ADDENDUM NO. 03
TO THE
CONTRACT DOCUMENTS

FOR
TAXIWAY A REHABILITATION (WEST)

AT
SYRACUSE HANCOCK INTERNATIONAL AIRPORT
SYRACUSE, NEW YORK

AUGUST 11, 2023

2
ED-01

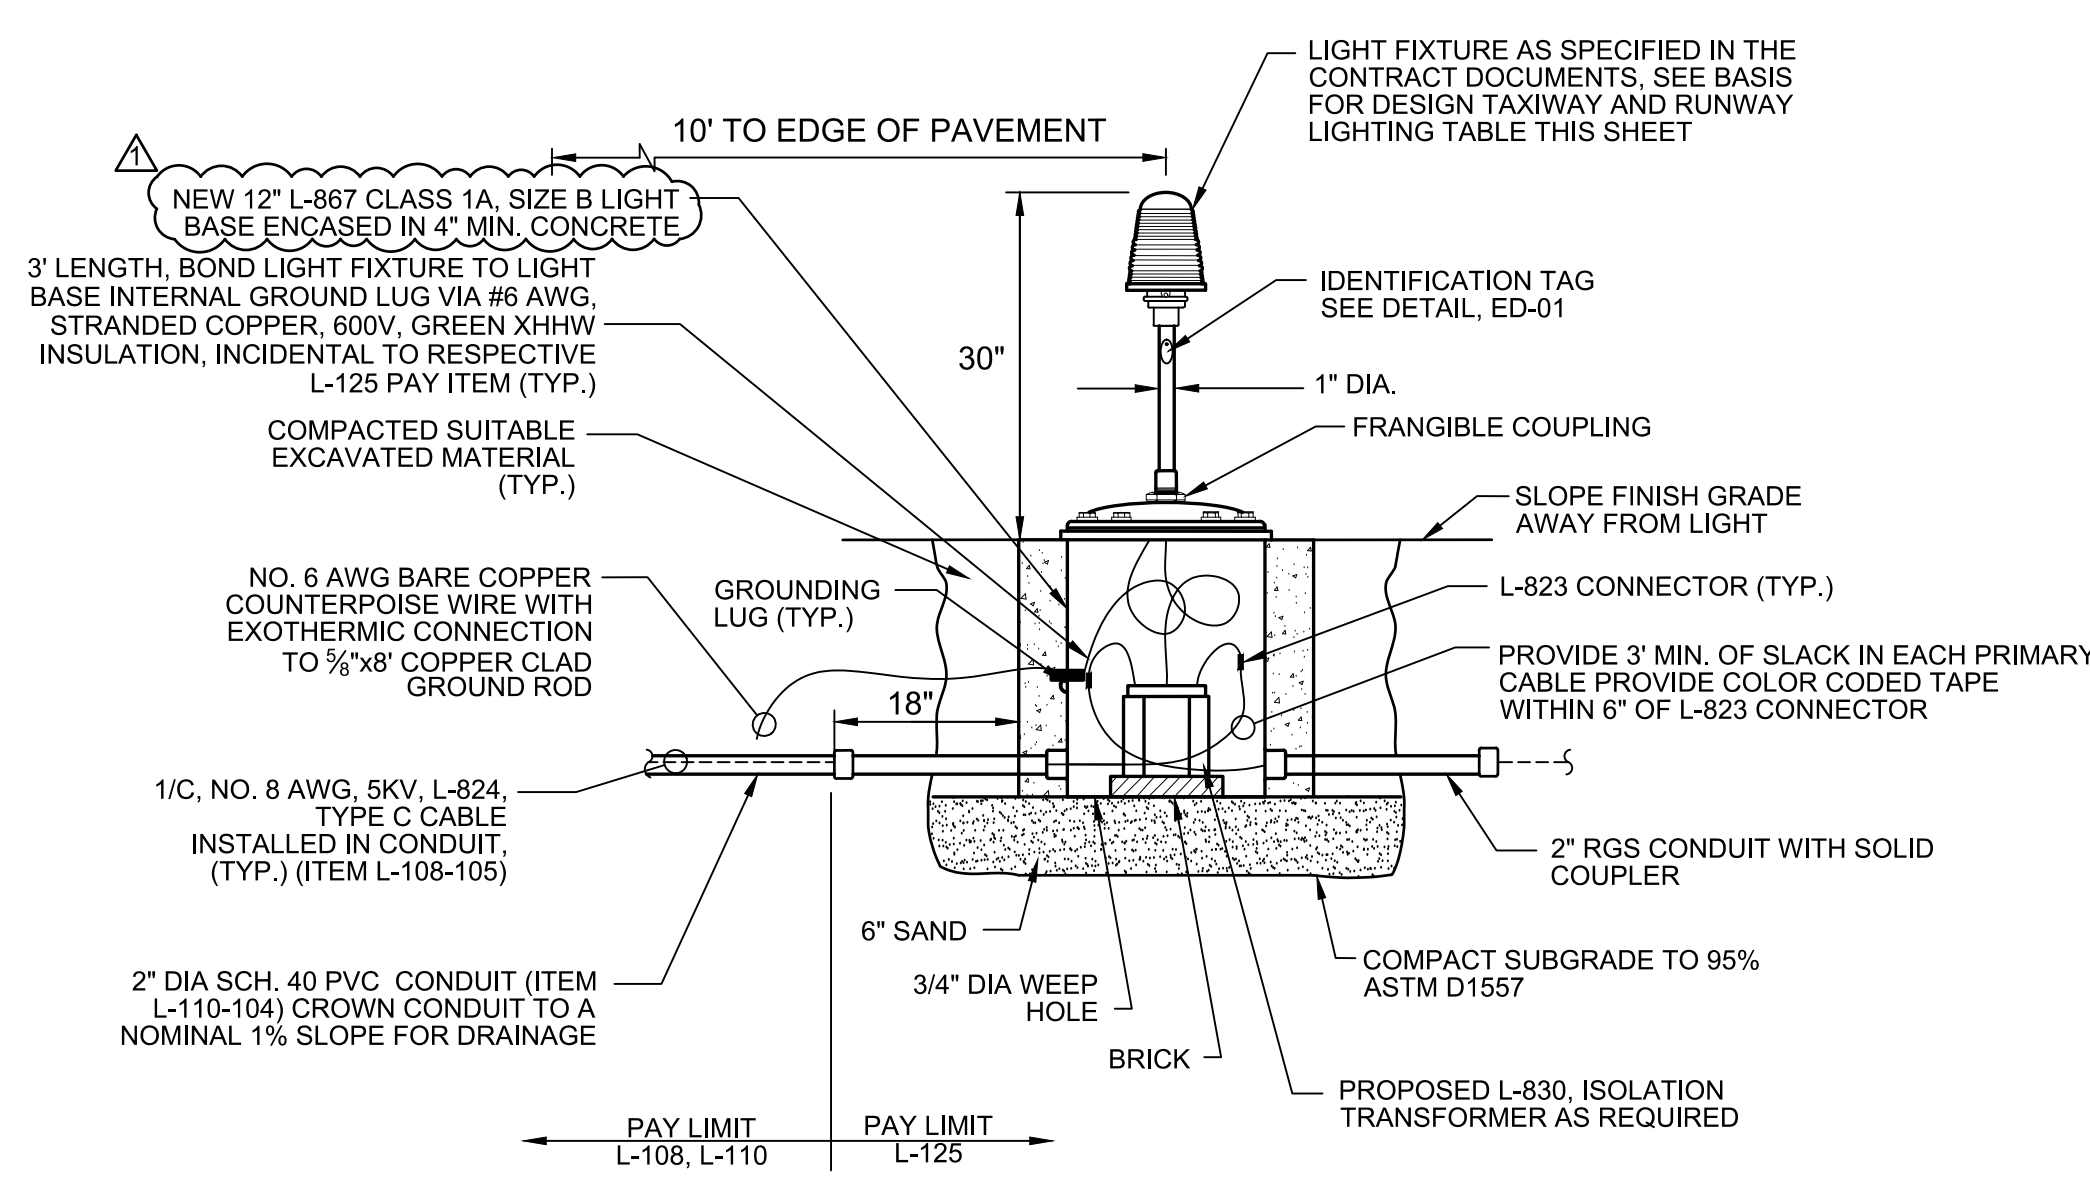
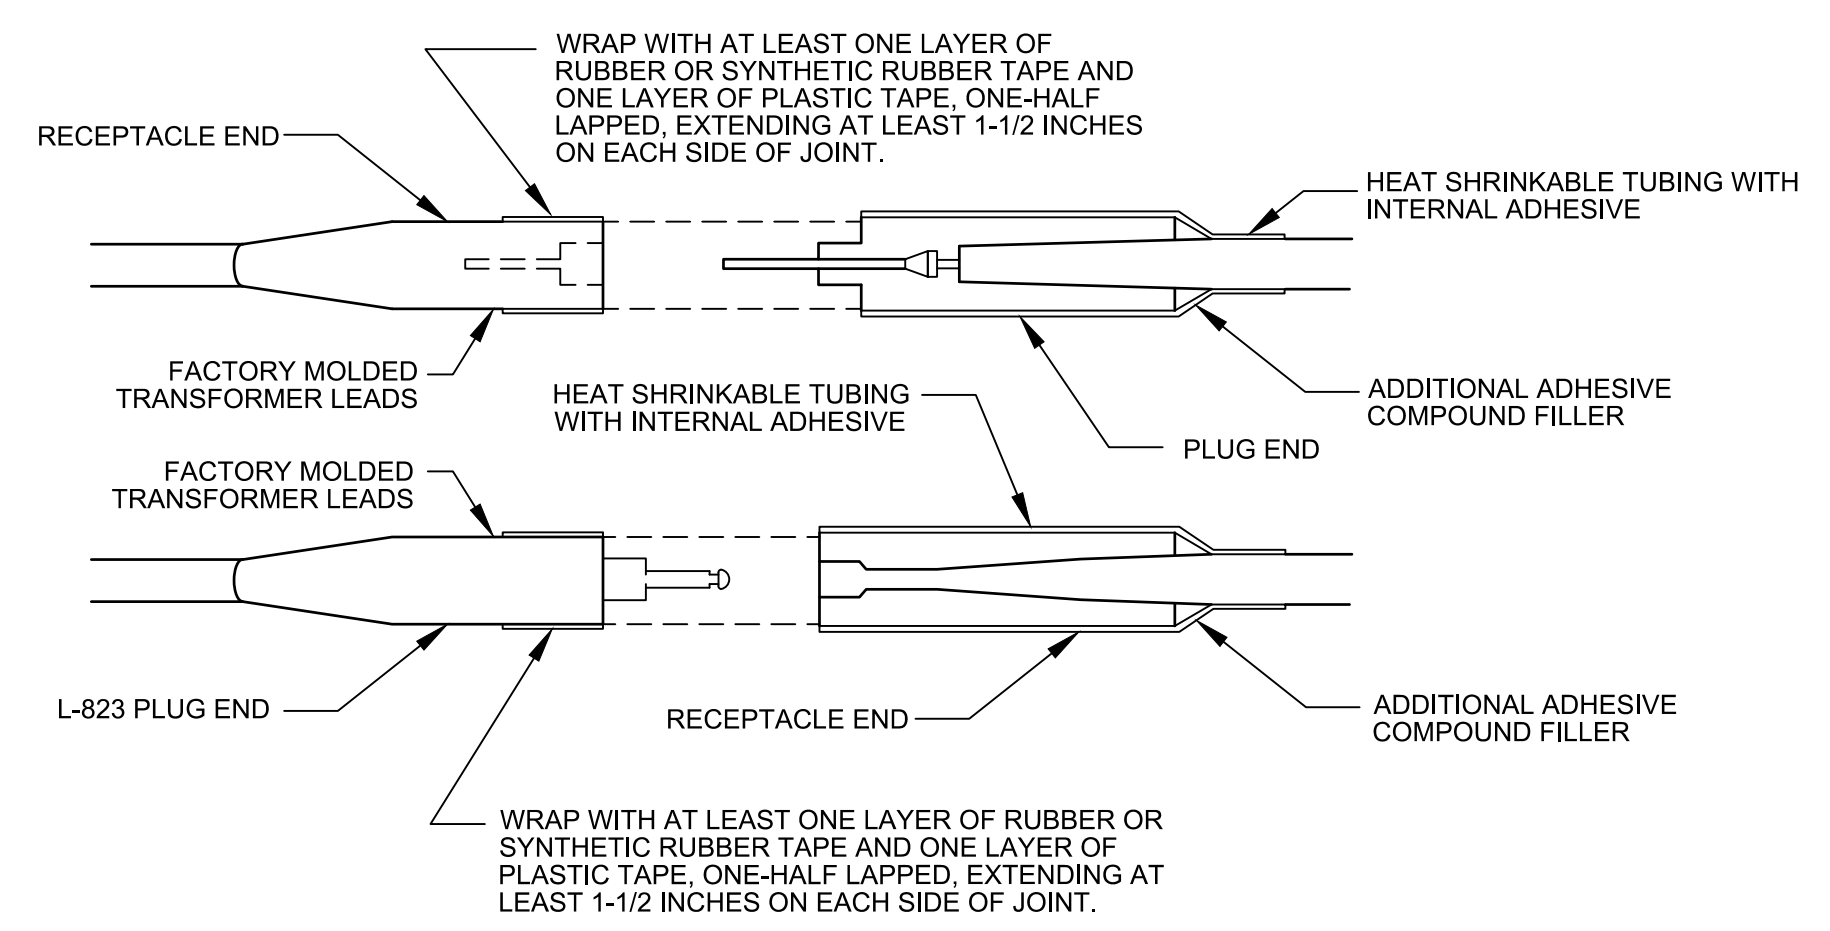
Q1: I am bidding the above project and I have questions on base cans. Per Spec 125-2.6 the base cans are class 1A size B – but the plans page ED-01 detail 2 – Calls out for 24” L-867 class 1B size B – which is correct? ED-01 – Basis for Design – note 2 – calls out for L-868 class 1A size B – Which is correct?

A1: All cans on the project (L-867 and L-868 type) shall be Class 1A, Size B. ED-01, Detail 2 and Basis for Design table have been revised accordingly.

ELECTRICAL DETAILS (SHEET 2 OF 4)

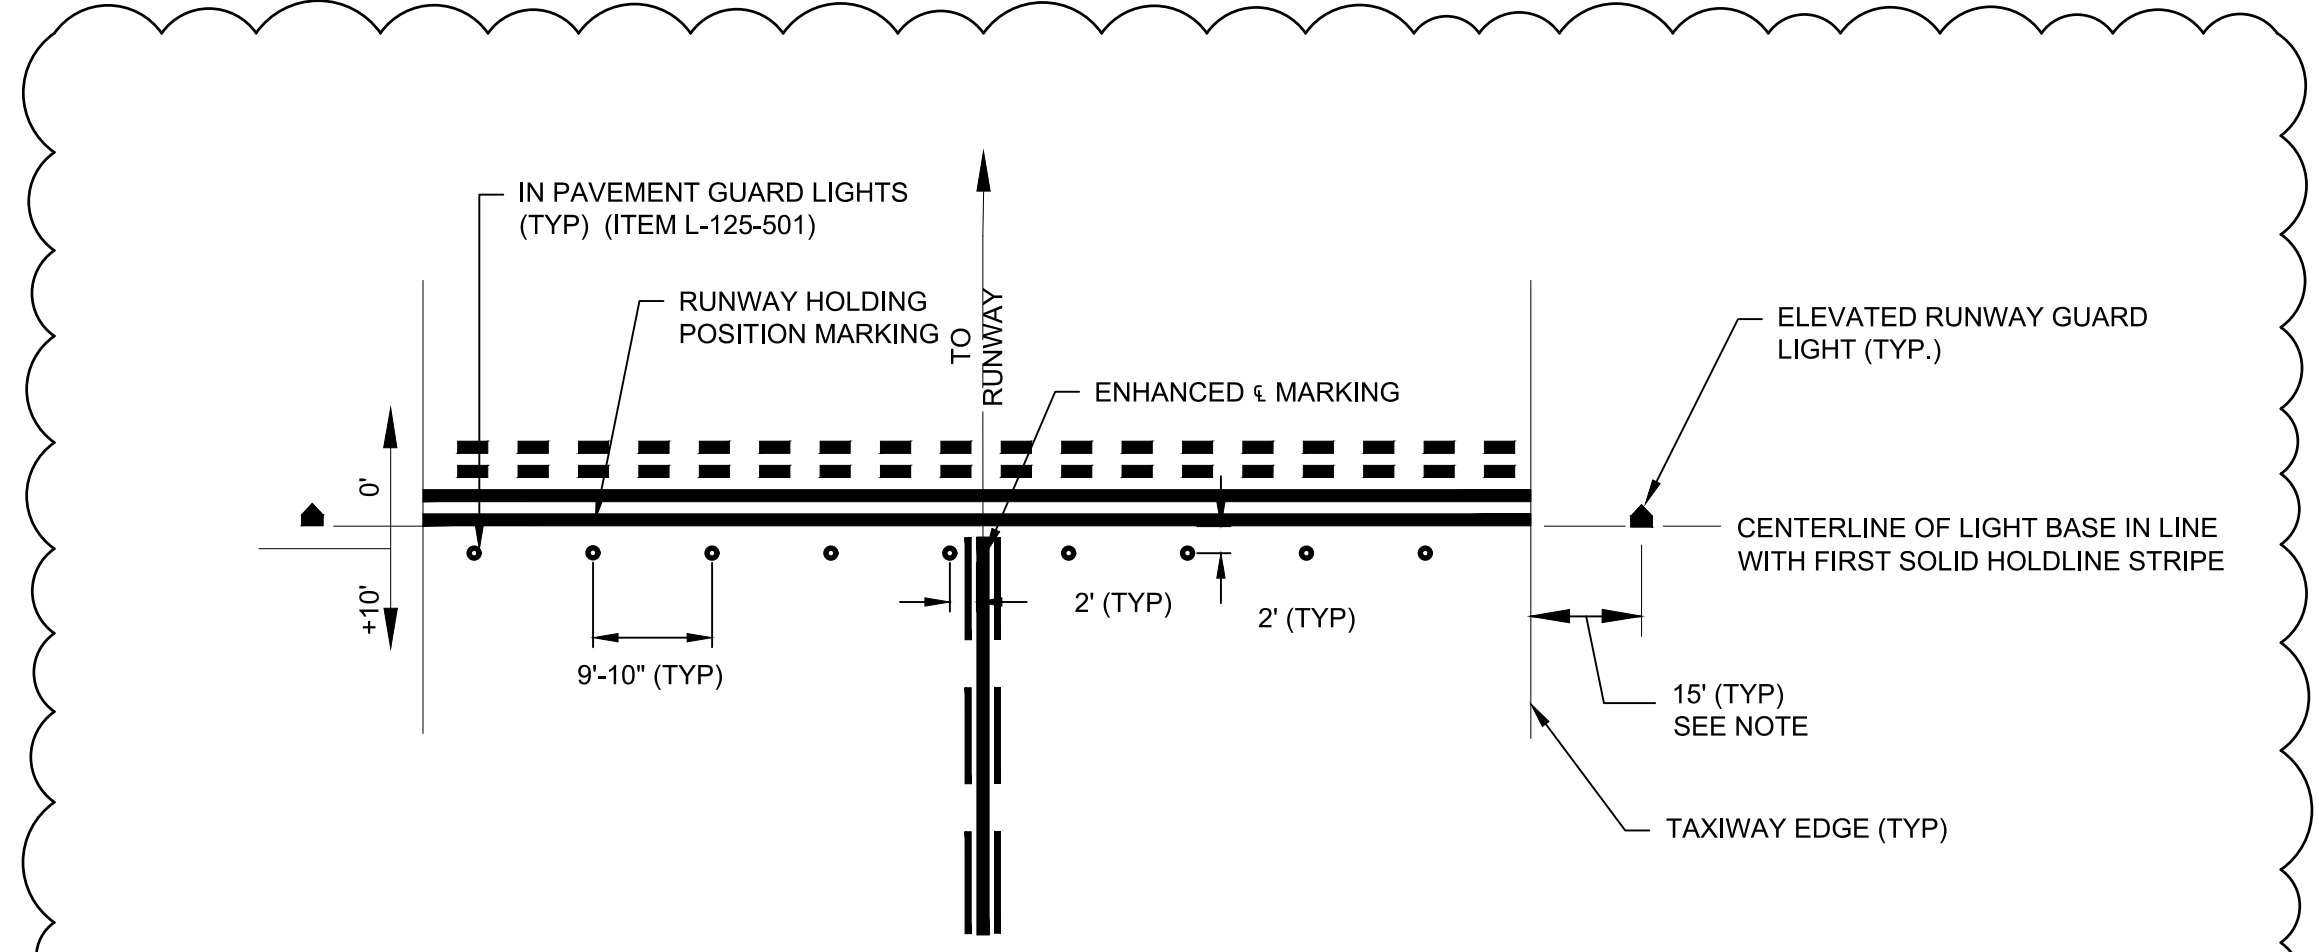
But the plan page ED-02 step 2 – Calls out for either a 10” (detail) or 12” (note 1) – which is correct?

ED-02 Step 2 – calls out for L-868 1A size B with 11-1/4” bolt circle but in the notes on the right side of the Basis for Design – Calls out for L-867 1A size B with 10-1/4” bolt circle – Which is correct?

But plan page ED-02 Basis for Design calls out for Style 3 inset but the Bolt Detail #2 calls out for Style 2 snow plow ring. – Which is correct? Please advise via addendum.

Cans for in-pavement guard lights shall be 12” diameter, L-868 base, Class IA.

“Elevated Runway Guard Light Installation Procedures” Notes 1 through 7 have been removed from ED-02 and do not apply to the project.

Snow plow rings shall be installed for all in-pavement guard lights. The correct Style is 2 – ¼ inch to ½ inch above finished grade. ED-02 Basis for Design Runway Guard Lighting table has been updated accordingly.
